**LOCAL HISTORIC DISTRICT:** Dilworth

**PROPERTY ADDRESS:** 1619 Lyndhurst Avenue

**SUMMARY OF REQUEST:** Addition

HDC-2019-00274

NEW RIGHT SIDE ELEVATION **02**  
1/4" = 1'-0"

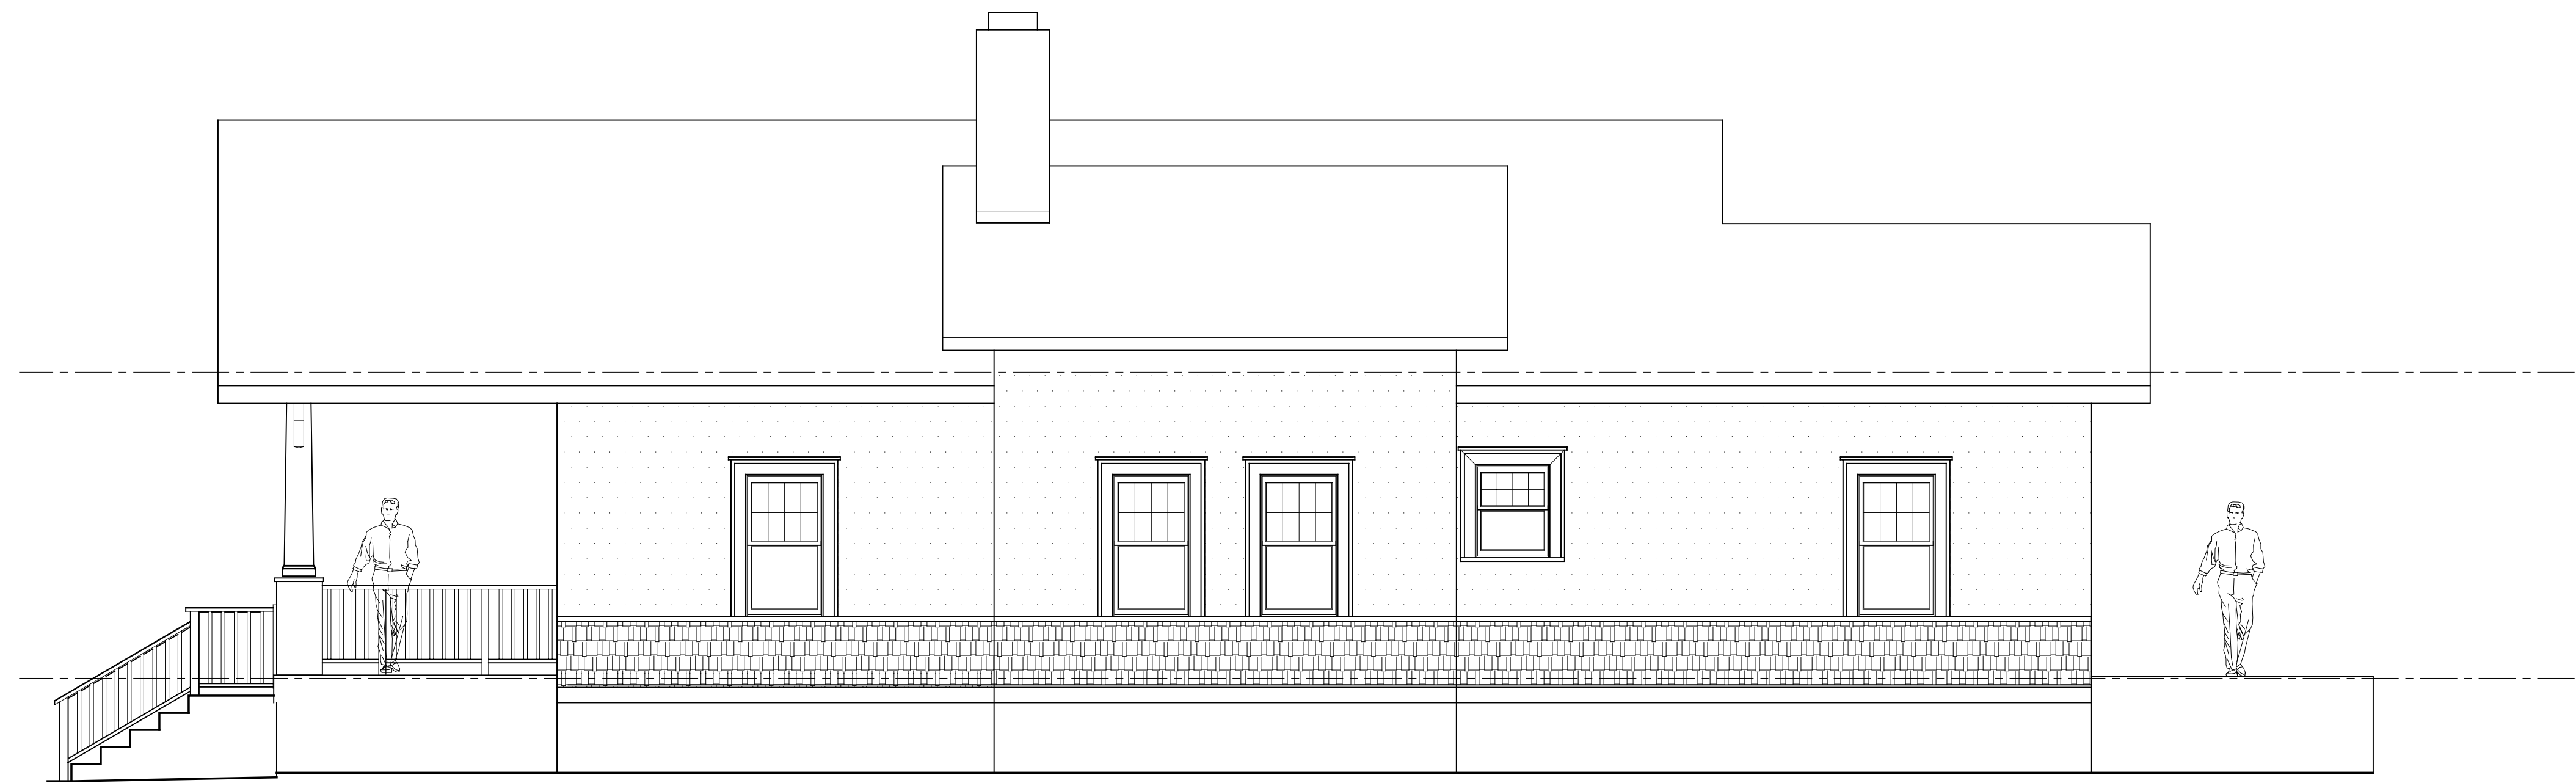
- ✓ Depth of rear porch, no less than 8 feet recommended – Changed to be 10' depth at the left rear, sheet A101.
- ✓ Beam detail at master bedroom porch – Changed to match the front of the house.
- ✓ Differentiation, old to new – Corner board detail added to show where original house ends.
- ✓ Windows added in master bedroom closet – Window added to right elevation, sheet A202
- ✓ All traditional materials labeled
